Conway  
Planning  
Commission  
STAFF REPORT

## CONWAY CITY PLANNING DEPARTMENT REVIEW LEWIS CROSSING PRELIMINARY PLAT SUBMITTED BY: COLLETT PROPERTIES FEBRUARY, 2015

BK. DEAN SUBDIVISION PRELIMINARY PLAT  
 SUBMITTED BY: 915 EAST OAK STREET, LLC  
 FEBRUARY, 2015

## CONWAY CITY PLANNING DEPARTMENT REVIEW NAHLEN COVE SUBDIVISION FINAL PLAT SUBMITTED BY: HAL CRAFTON JANUARY, 2015

# 1A LEWIS CROSSING PRELIMINARY SUBDIVISION

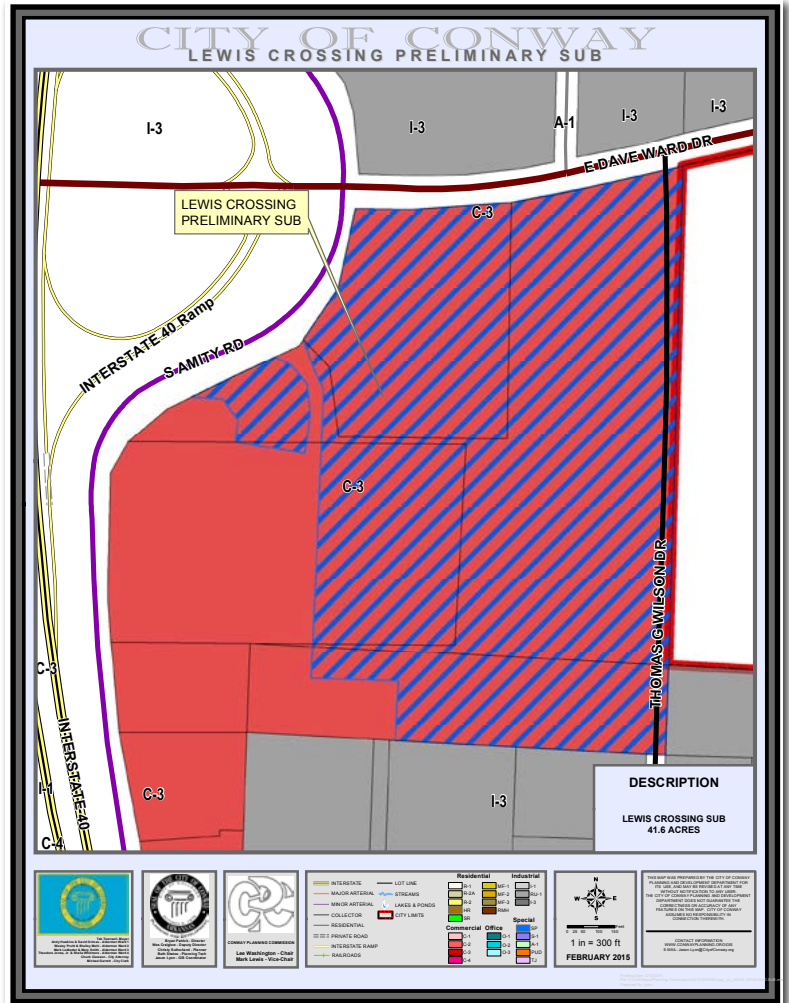
1. The name and address of all the owners of record are needed.
2. A vicinity map showing the location and acreage of the subdivision must be shown. The plat boundary and acreage must not include the Sam's Tract.
3. A legal description of the property with exact boundary lines, bearings and distances is needed. The legal description must show the boundary of all ten lots of the subdivision.
4. The present zoning classification of the adjoining land contiguous to the boundary of the proposed subdivision is needed. The east side of Thomas G. Wilson Drive is in the County and the south side of the subdivision is I-3. The Sam's Property is zoned C-3.

5. The zoning must be shown on the plat.
6. The layout of all proposed streets are needed, along with relevant dimensions and bearings.
7. Street names that are not similar to existing street names are needed for all proposed streets. The new public street must be shown as Amity Road and (Industrial Boulevard) must be changed to (East Dave Ward Drive).
8. Lot lines with appropriate dimensions are needed. Dimensions are needed on all lot lines.

20. The width of all streets must conform to the Master Street Plan and the requirements of Table 1, Street Classification & Design Standards, City of Conway in the Subdivision Ordinance. The width of the new Amity Road must be shown in the street & drainage plans.

21. The minimum horizontal radii of all streets must conform to the Master Street Plan and the requirements of Table 1, Street Classification & Design Standards, City of Conway in the Subdivision Ordinance. The Arkansas State Highway Department project continues on Amity Road just past the first turn south of the Dave Ward Amity roundabout.

22. Property line corners at street intersections shall be rounded with a radius of at least 28 feet. A 28 foot radius must be provided at the intersection of East Dave Ward Drive and Thomas G Wilson Drive.

23. Utility easements as required by Conway Corporation are needed.
24. Drainage easements as required by the City Engineer are needed.
25. Access, utility, drainage and storm water detention easements are difficult to follow. Please change the line type or hatch. Dimensions are required on all easements.

26. Lots must abut upon a public street except where private streets are approved by the Planning Commission in Planned Unit Developments or where a dedicated access easement 25' in width in C-1, C-3 or O-1 zones has been approved by the Planning Commission. A request for variance has been received to allow Lots 1, 4 & 5 to be platted without street frontage. A 25' public access will be provided to these lots. **The Planning Commission must approve this request or this condition must be corrected.**

29. Double frontage lots other than corner lots fronting on two streets shall not be platted except under extreme circumstances, as may be approved by the Planning Commission. A request for variance has been received to allow Lots 2, 3, 8 & 9 to be approved as double frontage lots. **The Planning Commission must approve this request or this condition must be corrected.**

- 35. Sidewalks are required along both sides of all streets within all zoning districts within Conway city limits and within the Conway Territorial Jurisdiction. The sidewalk on the north side of Lot #7 must extend east to the proposed access road.

- 36. The City Engineer has suggested payment in lieu instead of sidewalk construction adjacent to Thomas G. Wilson Drive and south of the Amity Road roundabout where street improvements will not be done by the developer. Any constructed sidewalk at this location by the Developer would likely be torn up when street improvements are done. If a waiver is granted, the developer shall contribute an amount of money in lieu of construction equal to \$15 per linear foot of the required sidewalk. *The Planning Commission must approve the payment in lieu at these locations only or sidewalks must be built.*

- 44. Sidewalks shall link sidewalks of adjoining lots so as to provide a continuous "ribbon" of pedestrian access throughout the community. Sidewalks must connect on the east side of Lot #3 and the south side of Lot #8.

Planning Staff recommends approval of this subdivision subject to the amended punch list.

# 1B BK DEAN PUD PRELIMINARY SUBDIVISION

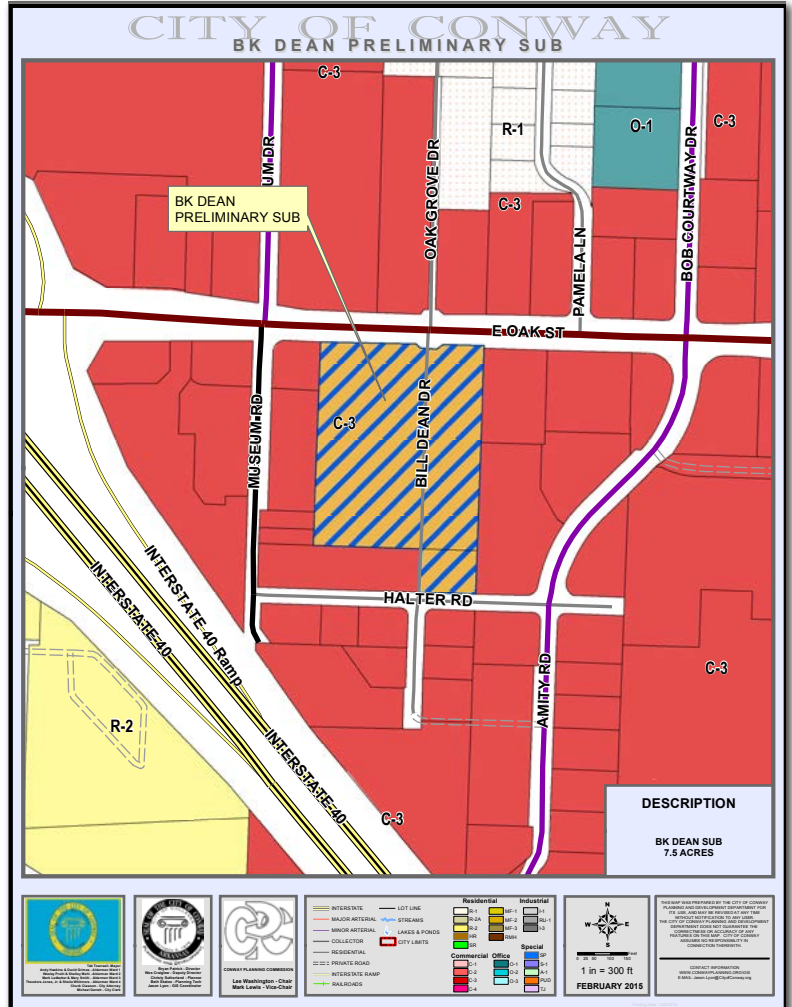
1. The name and address of all the owners of record are needed. The owner for the southern portion of Lot 5 must be shown.
2. The vicinity map must show the acreage of the subdivision.
3. The date of the survey is needed.
4. The boundary of the subdivision must be in a solid bold line with clear dimensions on the outside of the plat.
5. The present zoning classification of the adjoining land contiguous to the boundary of the proposed subdivision is needed.
6. The layout of all proposed sidewalk systems are needed, along with relevant dimensions and bearings.

14. Additional street paving and right-of-way, in the form of turning lanes may, upon consultation with the City Engineer and/or the Planning Staff, be required at Bill Dean Drive. A traffic study will be required to determine the need for the turning lane onto Oak Street.
15. Property line corners at street intersections shall be rounded with a radius of at least 28 feet.

16. Utility easements as required by Conway Corporation are needed.
17. Drainage easements as required by the City Engineer are needed. The method of drainage from the Hampton Inn property through this subdivision must be determined by an engineer and approved by the City Engineer and a drainage easement must follow this pathway.

18. All existing buildings must be shown to meet the minimum setback requirements from all lot lines or they must be modified or moved to meet those setback requirements. The existing structure from the old Superior Chevrolet Dealership must be removed before the filing of this plat.
19. Every lot must slope to a street or to a drainage easement.

Planning Staff recommends approval of this subdivision subject to the completion of the punch list.

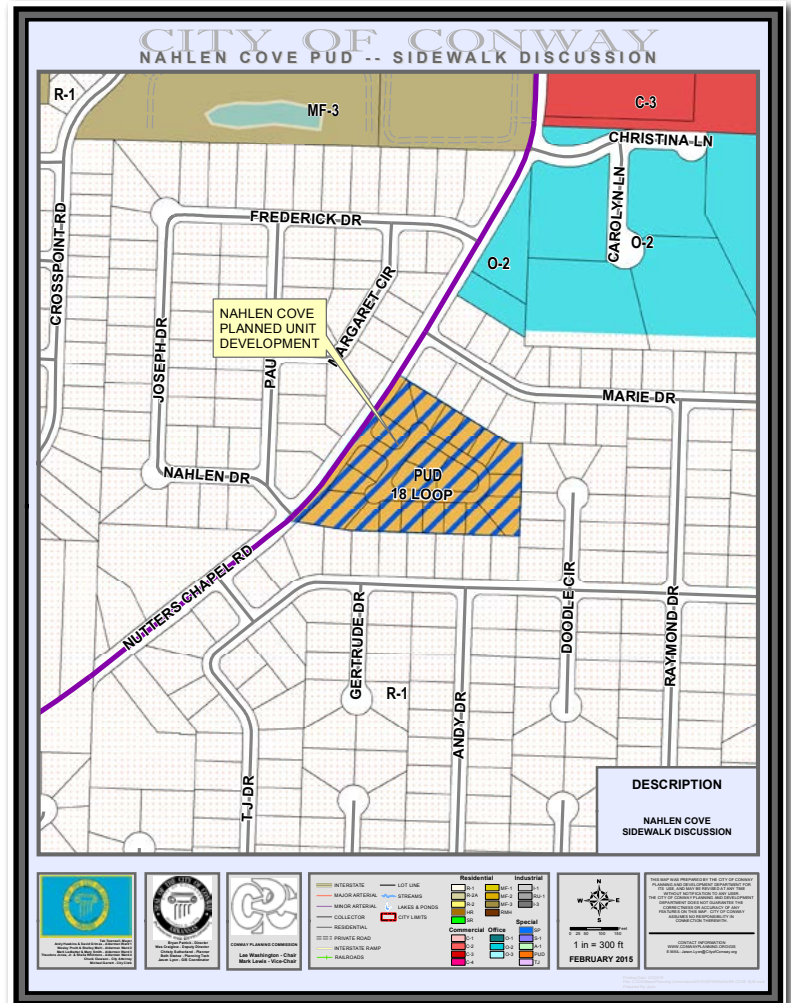
11. The rights-of-way of all streets must conform to the Master Street Plan and the requirements of Table 1, Street Classification & Design Standards, City of Conway in the Subdivision Ordinance. A request for variance has been received to allow a 35' right-of-way width with a sidewalk easement inside the lots instead of the required 50' right-of-way and sidewalks being constructed inside the right-of-way. *The Planning Commission approves this request.*
12. The minimum horizontal radii of all streets must conform to the Master Street Plan and the requirements of Table 1, Street Classification & Design Standards, City of Conway in the Subdivision Ordinance. A request for variance has been received to allow the minimum horizontal radii at C1 and C2 to be 4.25 instead of the minimum of 50' radii as in the Subdivision Ordinance. *The Planning Commission approves this request.*

13. Double frontage lots other than corner lots fronting on two streets shall not be platted except under extreme circumstances, as may be approved by the Planning Commission. A request for variance has been received to allow lots 1-2, 16-18 and 21 to be double frontage lots. *The Planning Commission approves this request.*
14. Addresses for each lot as assigned are needed on the plat.

15. A request for variance has been received to allow payment in lieu for sidewalks along Nutters Chapel Road due to shallow drainage and utilities at the placement of the sidewalk. Sidewalks will be built inside the subdivision. **The Planning Commission must approve this request or sidewalks must be built along the curb of the street.**
16. Sidewalk elevation. The sidewalk elevation shall be two (2) percent above the top of the curb, sloping two percent towards the curb (one-fourth inch in each foot). This elevation shall be continuous through the driveway approach.

Planning Staff recommends approval of this replat subject to the amended punch list.

CONWAY CITY PLANNING DEPARTMENT REVIEW  
WATSON FAMILY SUBDIVISION FINAL PLAT  
SUBMITTED BY: TOM WATSON TRUSTEE WATSON  
CHILDREN'S TRUST  
FEBRUARY, 2015

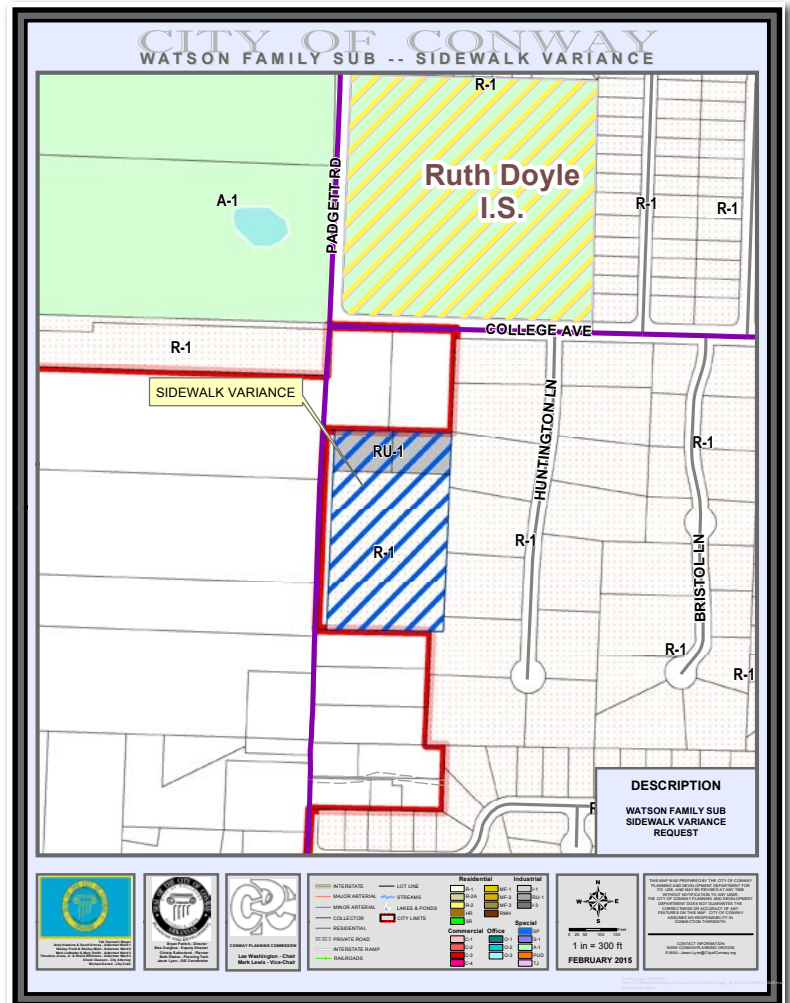
A request for variance has been received to pay in lieu instead of building the sidewalk along Padgett Road because of the constructed wrought iron fence. This fence is currently built approximately 13' inside the dedicated right-of-way from a dedication deed dated back September 12, 2003. The Faulkner County Assessor's Office shows the house to be completed in 2004. There are no permits for fences. This property is in the middle of approximately 1700' from April Drive in Westin Park Subdivision to Ruth Doyle Elementary. **The Planning Commission must approve the payment in lieu for a total of 250' or the fence must be**

Planning Staff recommends approval of this replat subject to the amended punch list.
